**Joint work with the Sub-Committee of Experts on the
Transport of Dangerous Goods (TDG Sub-Committee)**

Amendments to chemicals under pressure and aerosols

Transmitted by the expert from Germany

Table 2.3.2 Criteria for chemicals under pressure

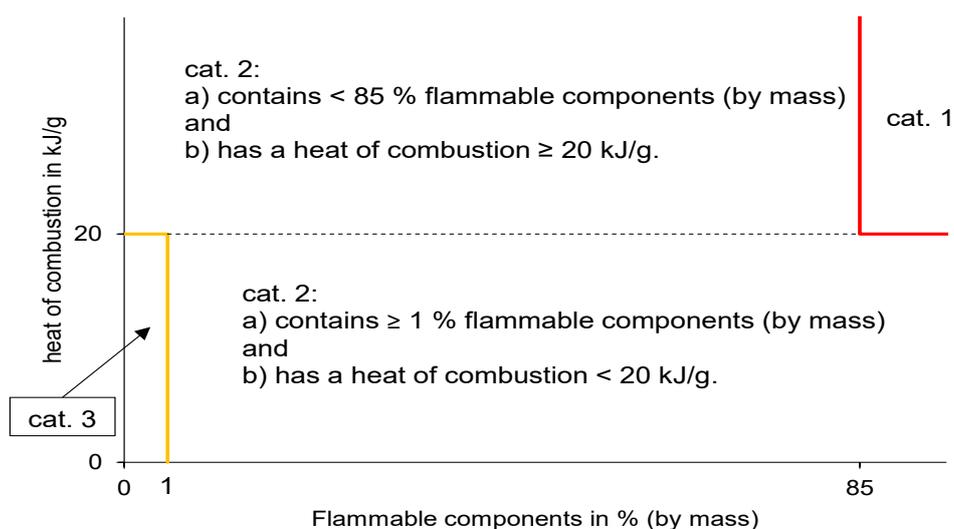
Replace sections 2.3.2.2.1 to 2.3.2.2.4 by the following (amendments are underlined, deletions are not shown in order to be better legible):

Every physical hazard class (except chapter 2.8 and 2.15) contains a criteria table (for aerosols it is supposed to be introduced with ST/SG/AC.10/C.4/2018/9). It is therefore suggested to introduce a criteria table for chemicals under pressure as well. The contents of that criteria table would reflect what currently is proposed for sections 2.3.2.2.2 to 2.3.2.2.4. These paragraphs therefore are no longer needed and the presentation of the criteria then would be in line with how the criteria are usually presented in the GHS.

The added wording of the criteria for category 2 becomes clear with the following chart:

<u>Category</u>	<u>Criteria</u>
1	Any chemical under pressure that a) contains $\geq 85\%$ flammable components (by mass) and b) and has a heat of combustion of ≥ 20 kJ/g.
2	Any chemical under pressure that a) contains $\geq 1\%$ flammable components (by mass) and b) has a heat of combustion < 20 kJ/g or that a) contains $< 85\%$ flammable components (by mass) and b) has a heat of combustion ≥ 20 kJ/g.
3	Any chemical under pressure that a) contains $\leq 1\%$ flammable components (by mass) and b) and has a heat of combustion of < 20 kJ/g."
